# Service Bulletin

## PRELIMINARY INFORMATION

**Subject:** Intermittent Clicking/Rubbing Noise when Side Door Glass is Moving Up or Down at Cold Temperatures

**Models:** 2015 Cadillac Escalade  
2015 Chevrolet Silverado, Suburban, Tahoe  
2015 GMC Sierra, Yukon, Yukon XL

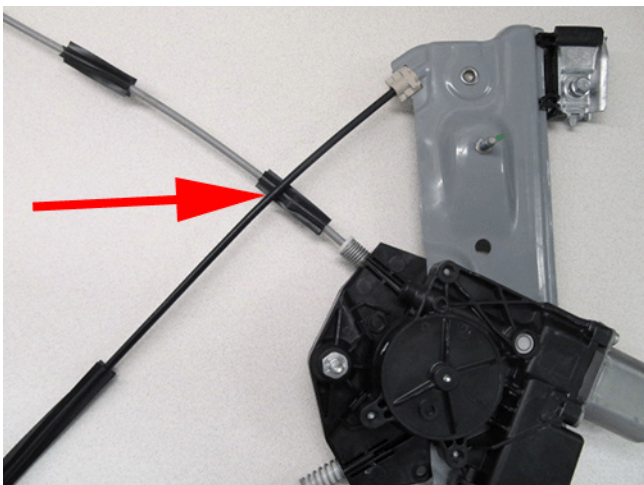
Some customers may comment on an intermittent clicking or rubbing noise when the side door glass is moved up or down. The noise may be more predominant when the glass is approximately half way down, when ambient temperatures are colder, and the glass is dry. The noise may not be as present when the vehicle doors or glass reaches warmer temperatures.

This may be caused by an incorrectly routed window regulator cable, causing a noise that could be described as a click or rub.
